CITY PLAN COMMISSION**THURSDAY, OCTOBER 6, 2022****FILE NUMBER:** S212-338**SENIOR PLANNER:** Mohammad H. Bordbar**LOCATION:** Empire Central, southwest of Forest Park Road**DATE FILED:** September 9, 2022**ZONING:** IR**CITY COUNCIL DISTRICT:** 2 **SIZE OF REQUEST:** 1.851-acres**MAPSCO:** 34N**APPLICANT/OWNER:** Slate Properties

REQUEST: An application to replat a 1.851-acre tract of land containing all of Lots 5 through 9 in City Block 6/8570 and a tract of land in City Block A/5760 to create one lot on property located on Empire Central, southwest of Forest Park Road.

PRELIMINARY PLAT

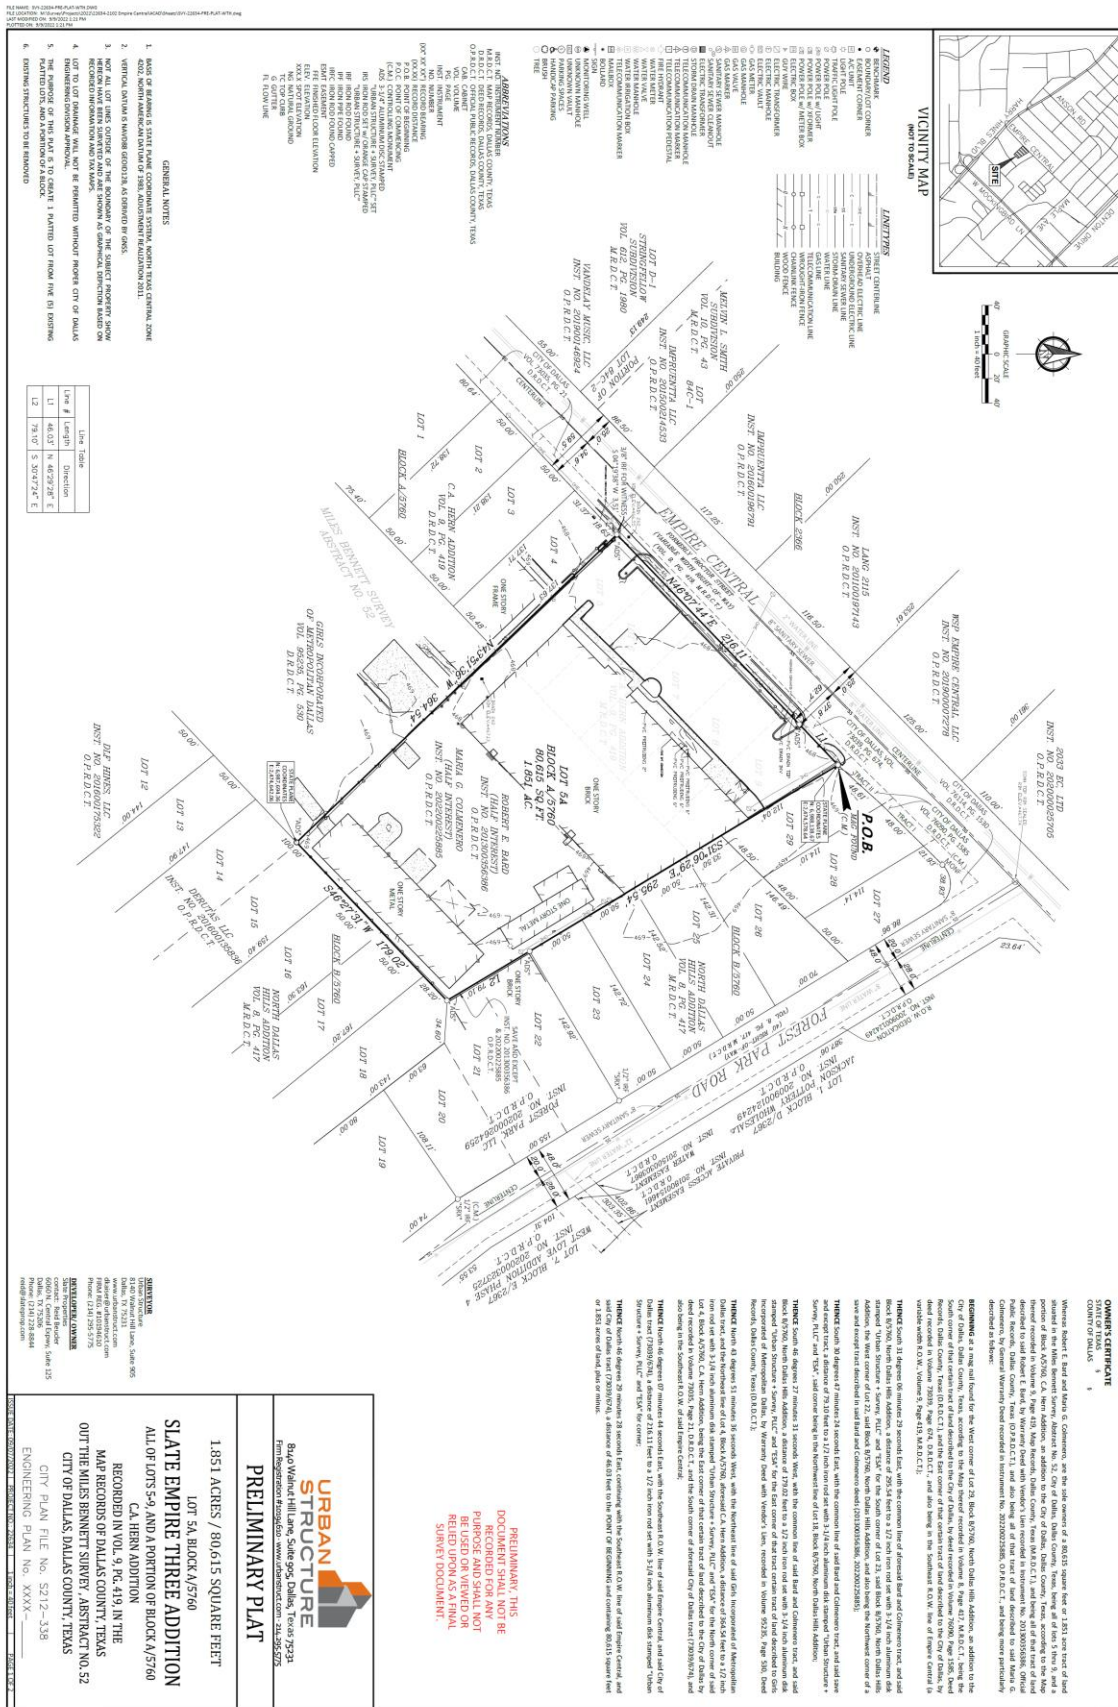
15. Prior to final plat, submit a completed final plat checklist and all supporting documents.
16. On the final plat, show the correct recording information for the subject property. Platting Guidelines.
17. On the final plat, dedicate street easement in fee simple.
18. On the final plat, clarify street easement.

19. Additional design information is required for assessment. Site plan must be submitted showing proposed development, building finished floor elevation, development, existing mains – including downstream manhole, and proposed water and wastewater service locations. Submit water/wastewater engineering plans to 320 E. Jefferson Blvd., Room 200, Attention: Water and Wastewater Engineering.
20. Water and wastewater main improvements maybe required by Private Development Contract. Submit water/wastewater engineering plans to 320 E. Jefferson Blvd., Room 200, Attention: Water and Wastewater Engineering.

21. On the final plat, change "S. Corinth Street Road" to "Hutchens Road". Section 51A-8.403(a)(1)(A)(xii)
22. On the final plat, identify the property as Lot 5A in City Block A/5760. Ordinance 1A, Page 131 pages 131-148, Section 2 (passed August 13, 1872).
